DCP PACKAGE INDEX
ITEM NO. 6.2.25

BECTEL
SAN FRANCISCO
DUANE ARNOLD ENERGY CENTER - UNIT NO 1
IOWA ELECTRIC LIGHT AND POWER COMPANY
CEDAR RAPIDS, IOWA

SCHMATIC DIAGRAM
ANNUNCIATORS CABINETS IC08-B

JOB NO.	7884	DRAWING NO.	BECH-E037	REV.	12
---------	------	-------------	-----------	------	----

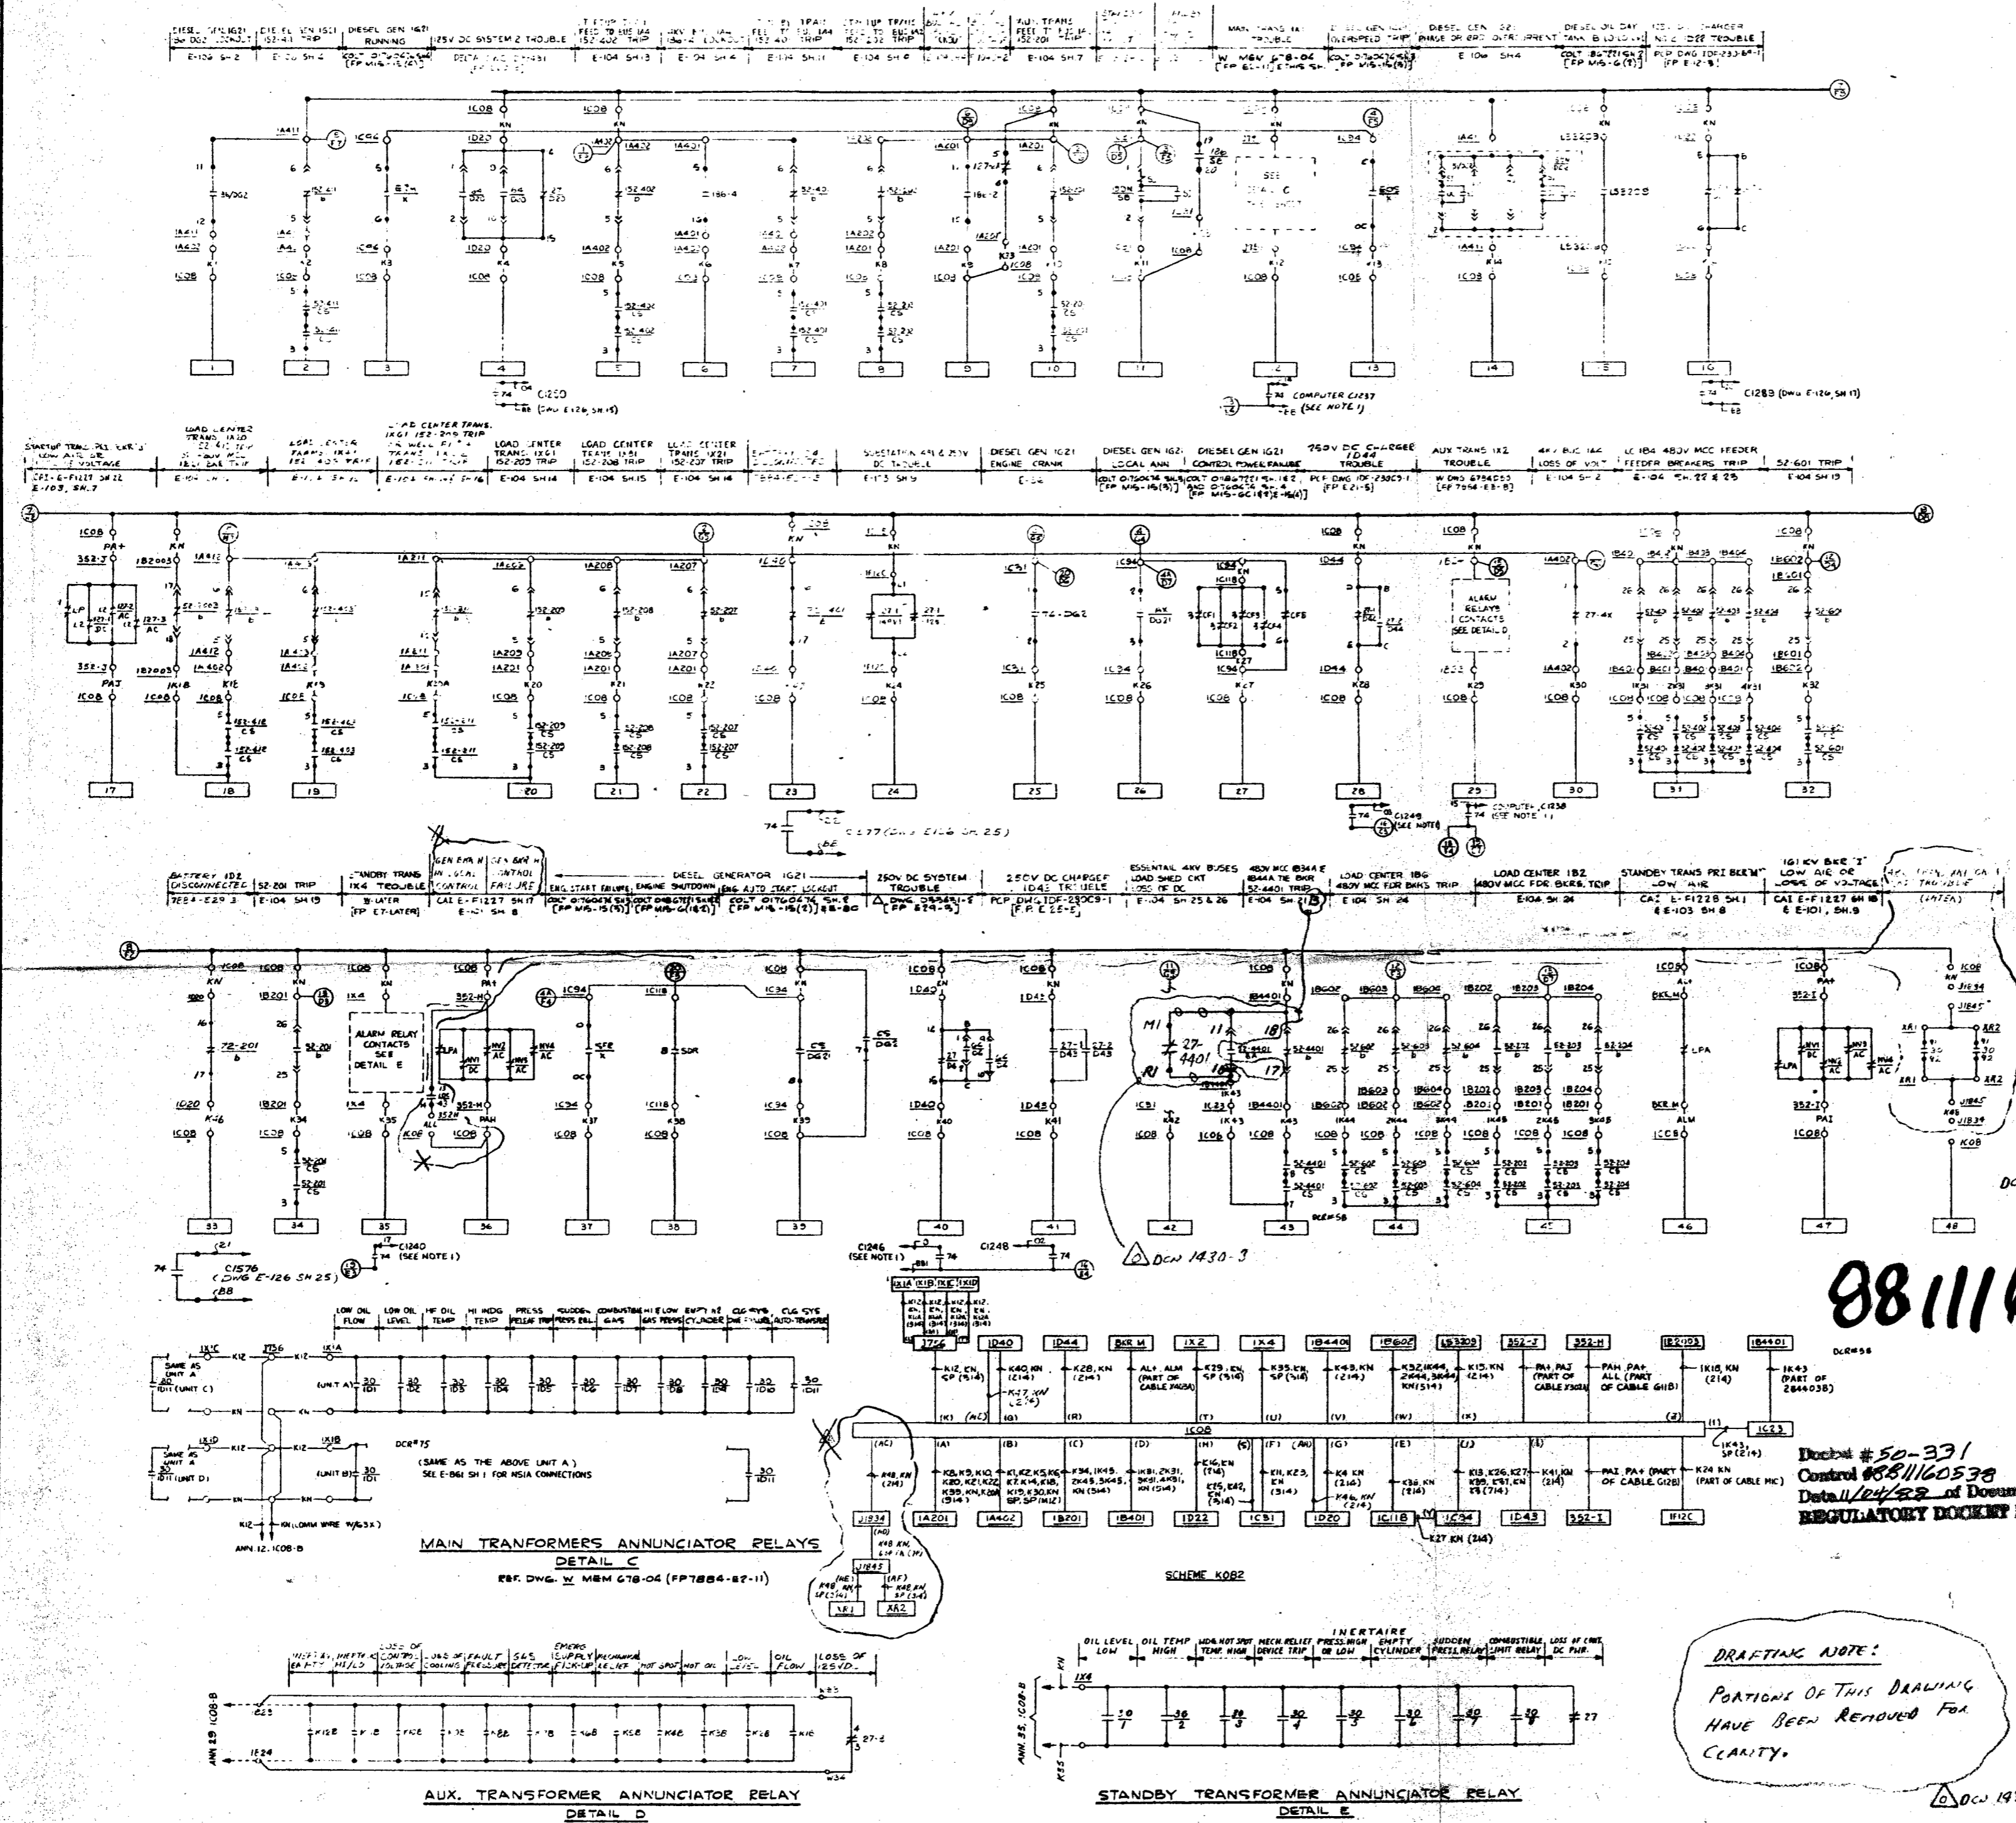
DRAFTING NOTE:
CLOUDED WIRES & CABLES OR \odot - \odot CODED WIRES & CABLES ARE NEW ADDED WIRES & CABLES. DO NOT DRAFT THE "O" ON THE WIRES & CABLES AT DCP CLOSURE.
